Section 75W to Stage 1 Mixed Use Development (MP10_0030)

Discovery Point, Wolli Creek

Submitted to Department of Planning and Infrastructure
On Behalf of Discovery Point Pty Ltd and Discovery Point Devt Pty Ltd

August 2012 ■ 12505

Figure 2 – Site Plan

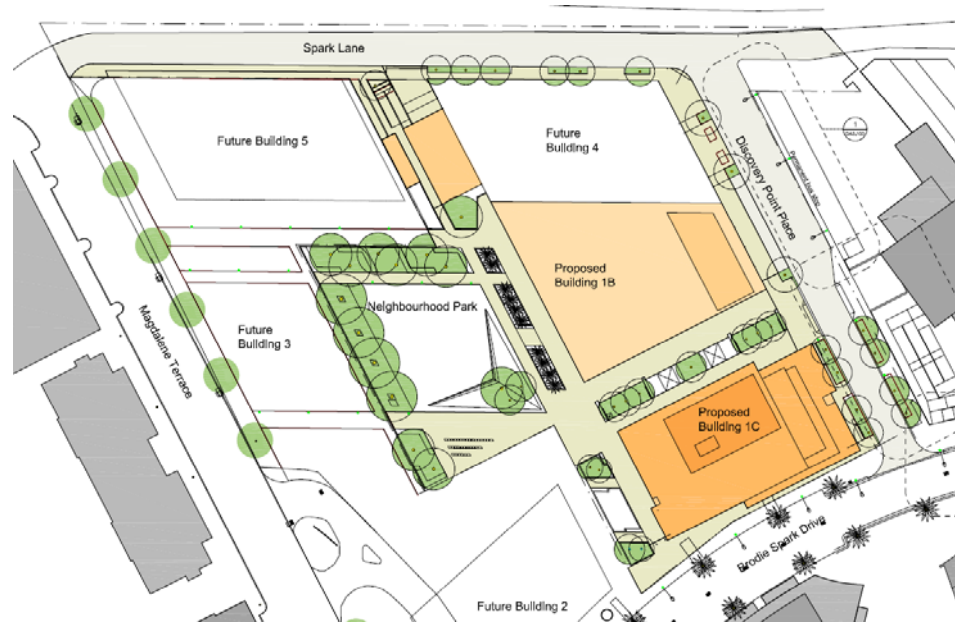
In addition, due to a revision in the extent of the site establishment zone and construction methodology in delivering Stage 1, a temporary park is no longer proposed to be established along Magdalene Terrace on future building sites 3 and 5 (refer to **Figure 2**).

Figure 3 – Extract of approved landscape plan for Neighbourhood Park

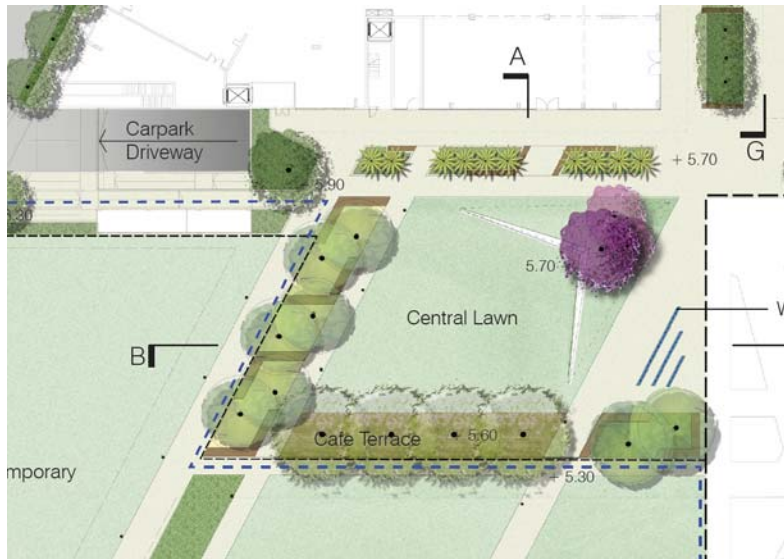
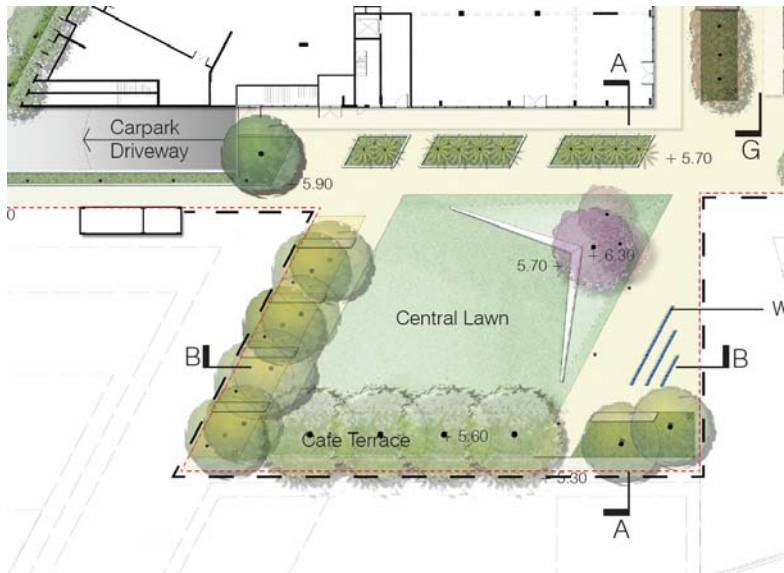
Importantly, there will be no change to the approved landscape design as a result of extending the basement carpark below the Neighbourhood Park (as evident from a comparison between **Figures 3** and **4** below). Central to achieving this outcome is the critical similarities (as identified within **Appendix E**) in the setting of the Neighbourhood Park between the approved and proposed concepts. In the approved design the Neighbourhood Park was to be installed over compacted fill. This would have prevented root breakout to the underlying deep alluvial sands and watertable (i.e. the containerisation of the planting elements). The current proposal for the Neighbourhood Park to be located over a basement structure therefore effectively creates the same underlying conditions for the trees and turf.

Overall, the proposed soil zone, depth and drainage arrangements are adequate (as confirmed by the arborist) to accommodate all the features of the approved park, including:

In summary, subject to the adoption of the recommendations outlined by the specialist soil consultant, arborist and engineer in terms of drainage (which have been reflected in the revised architectural, landscaping and engineering plans) the growing conditions within the Neighbourhood Park are considered to be acceptable with trees expected to achieve good growth and longer term viability.
